**FINAL DRAINAGE REPORT
FOR
STERLING RANCH FILING NO. 2**

Engineering Review

**EPC Planning & Community
Development Department**

PCD File No. SF-20-015

DRAINAGE MAP
 STERLING RANCH FILING 2
 JOB NO. 25188.01
 5/15/20
 SHEET 1 OF 6

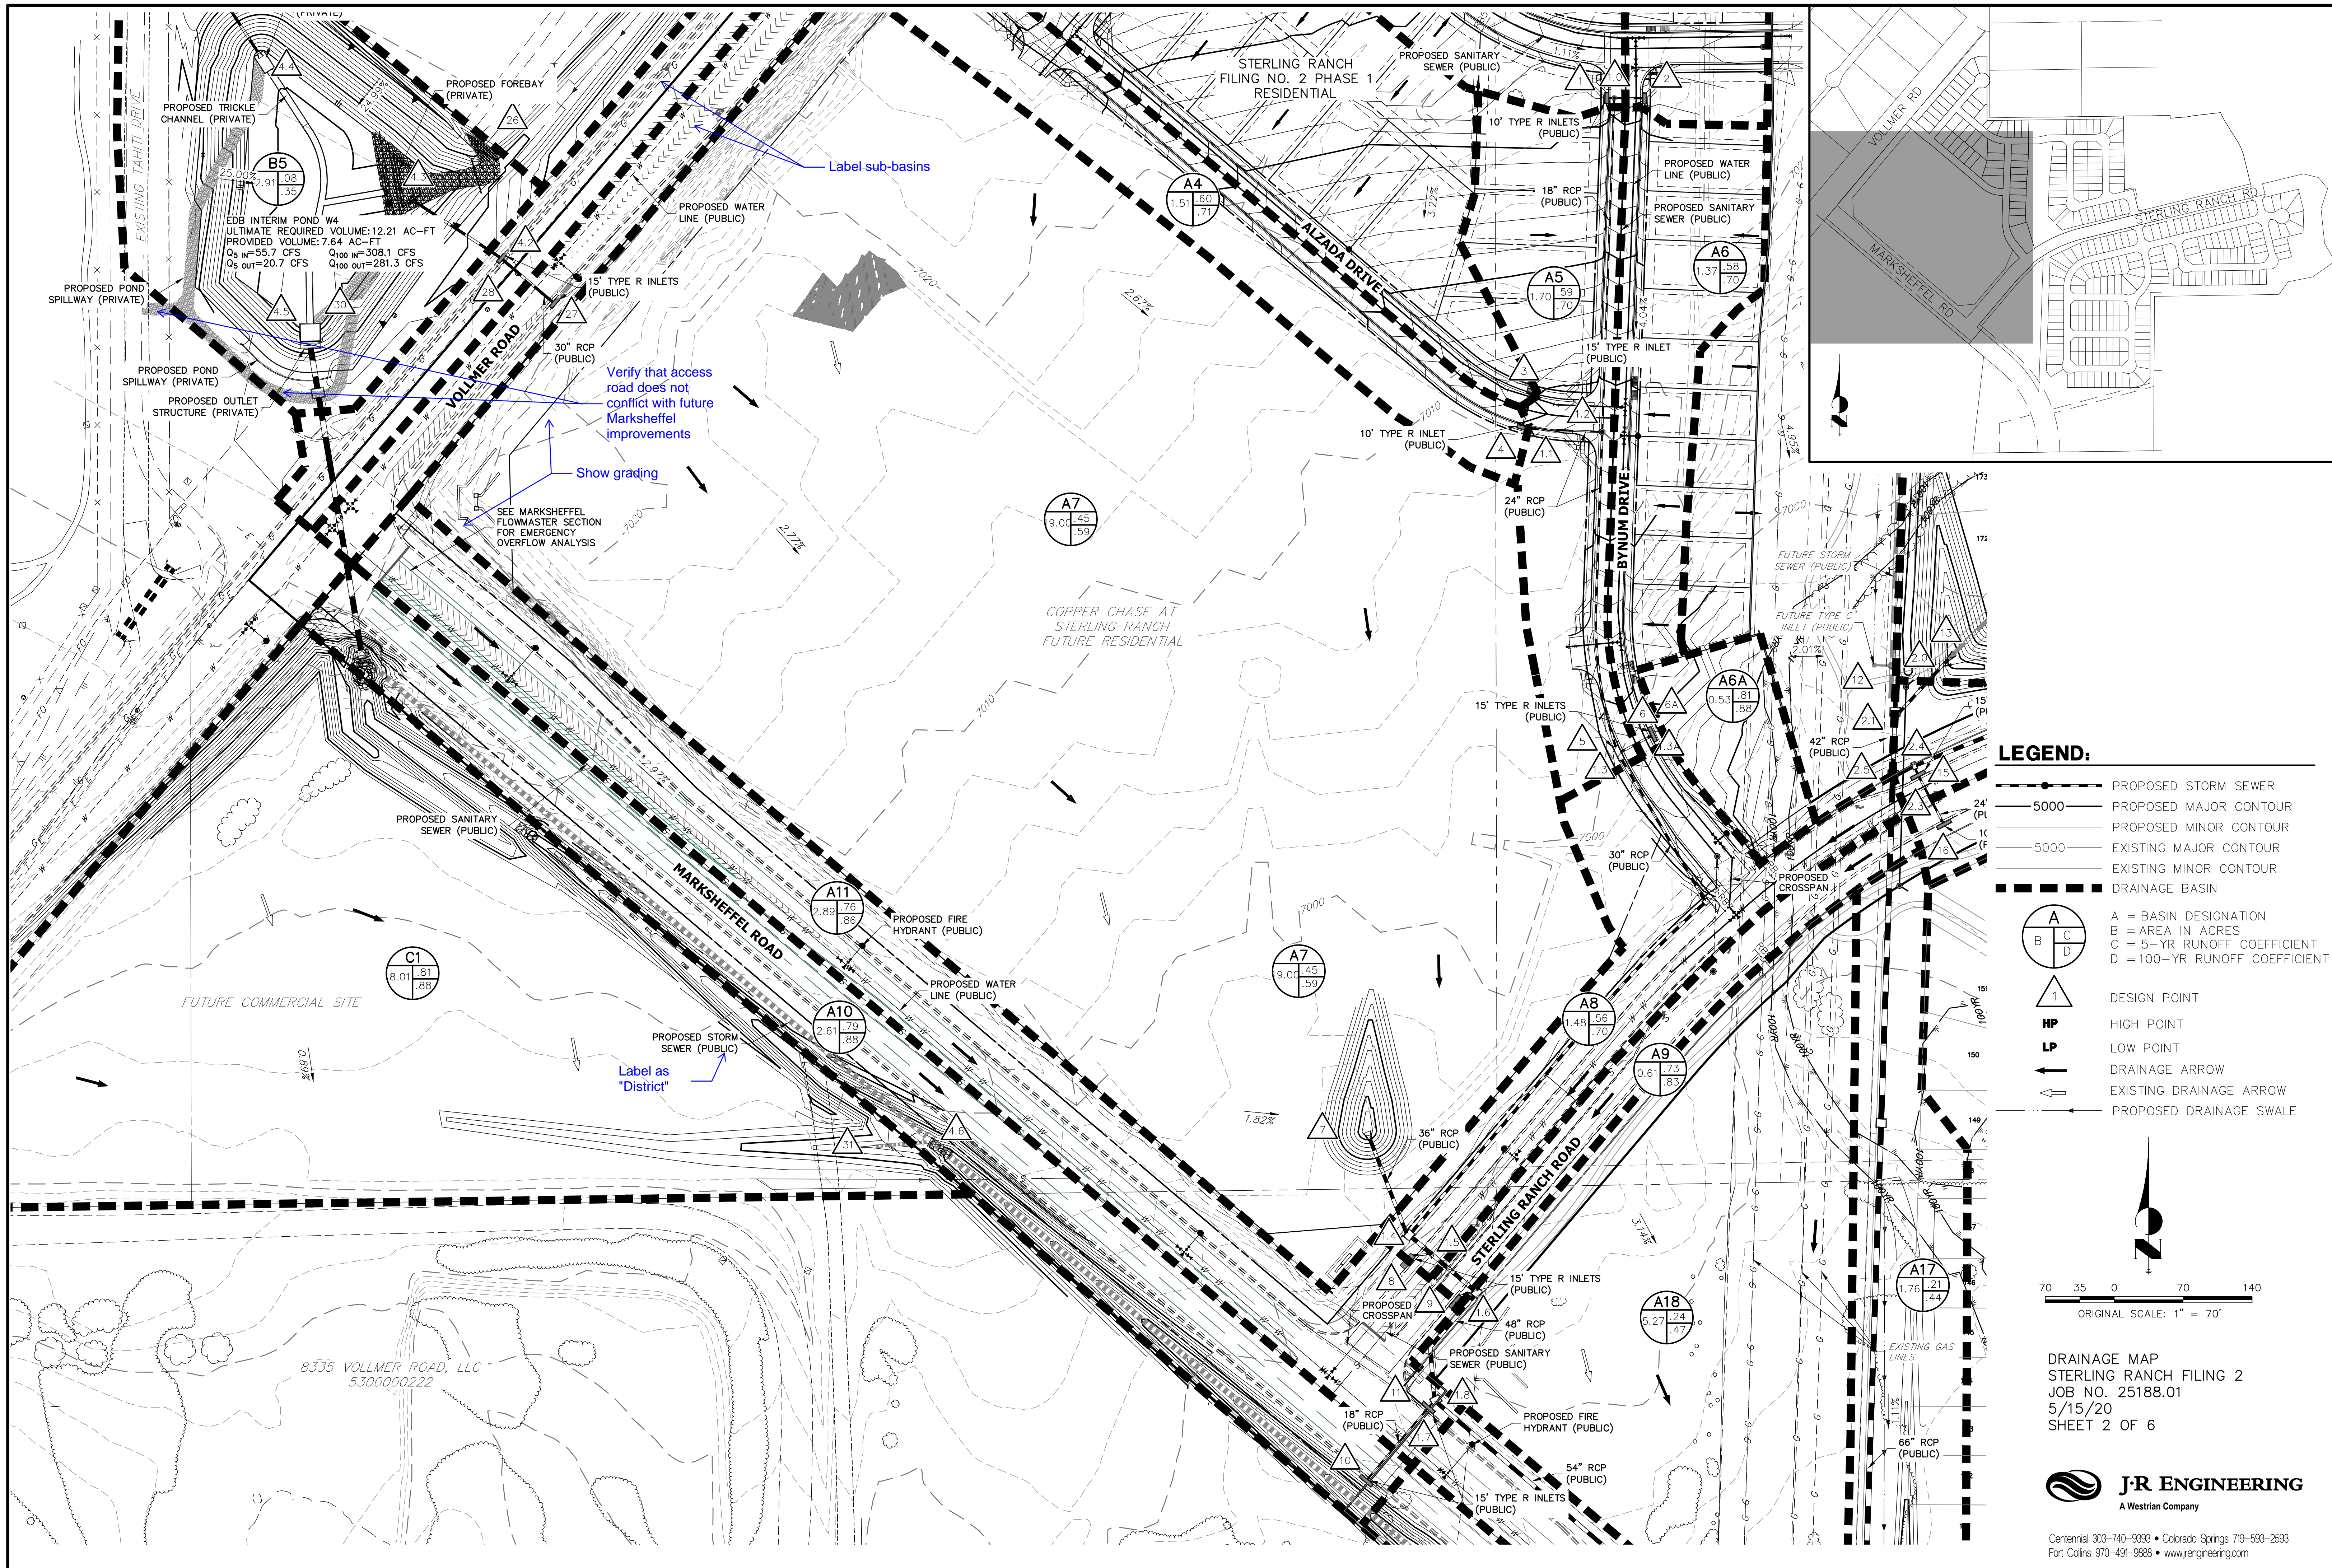
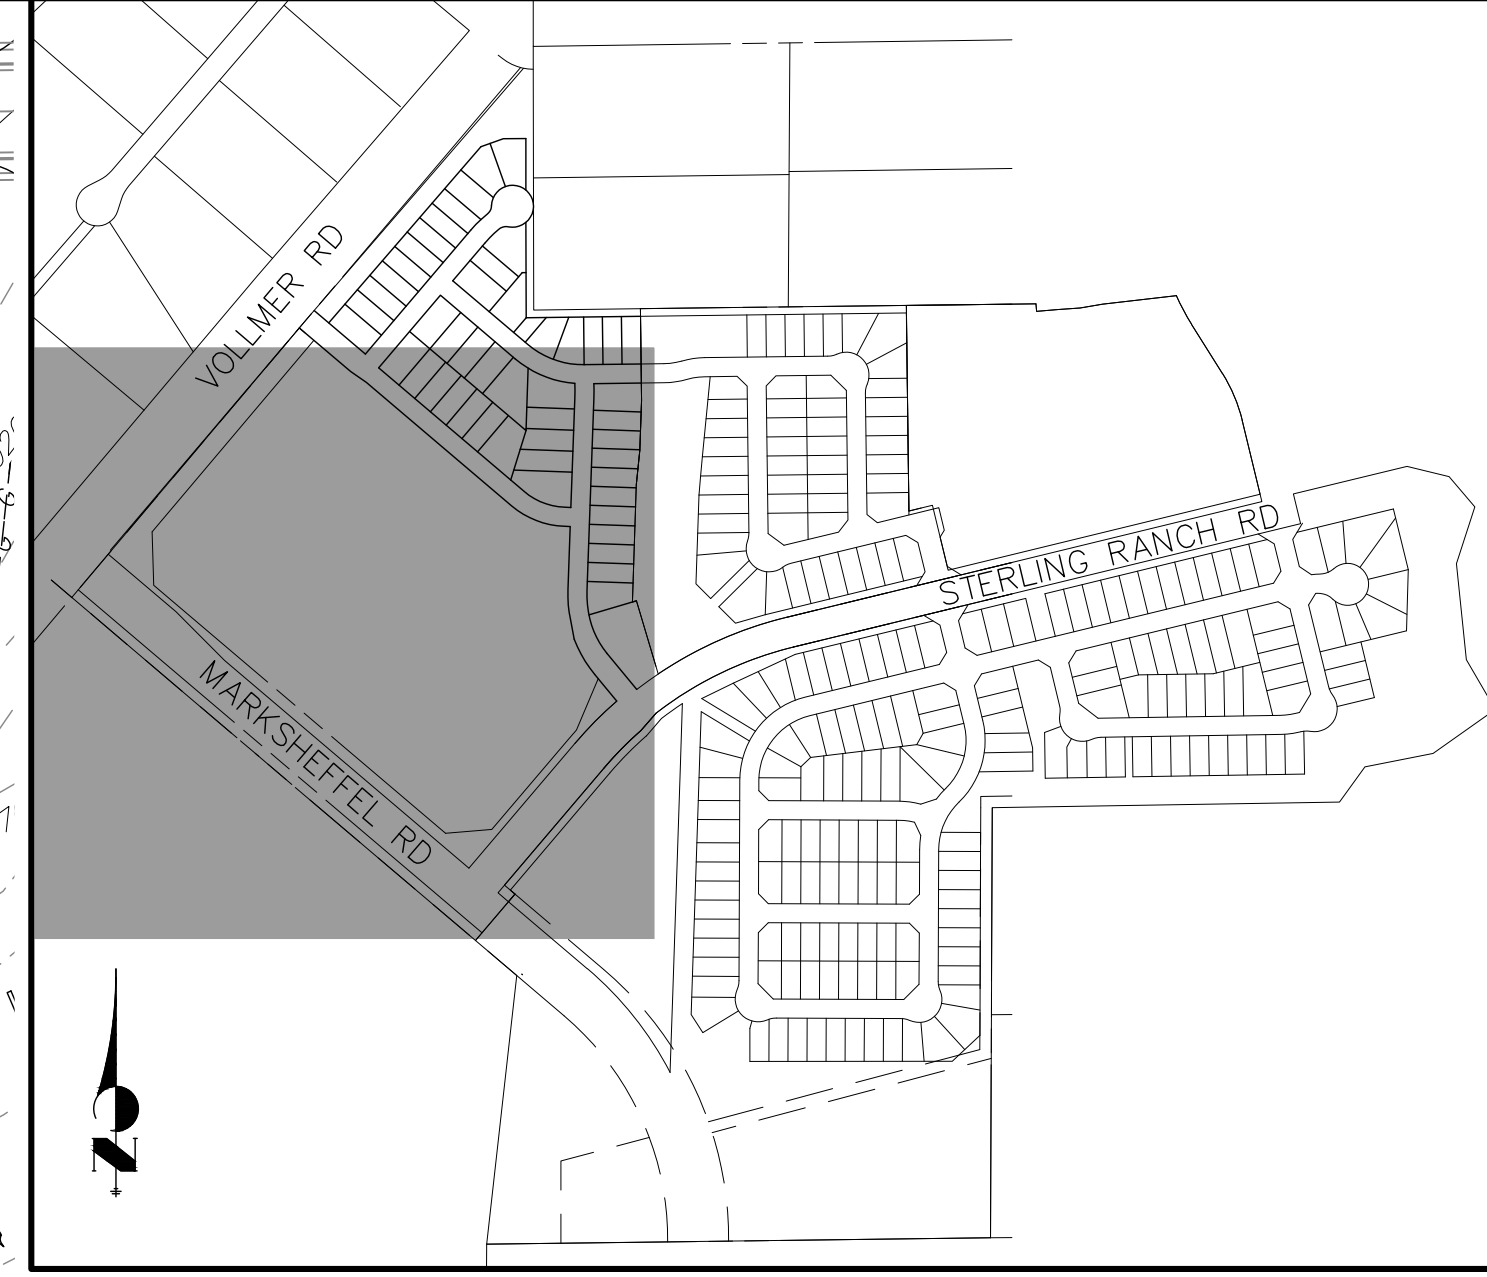
Obtain City approval for maintenance access roads from Marksheffel Road.
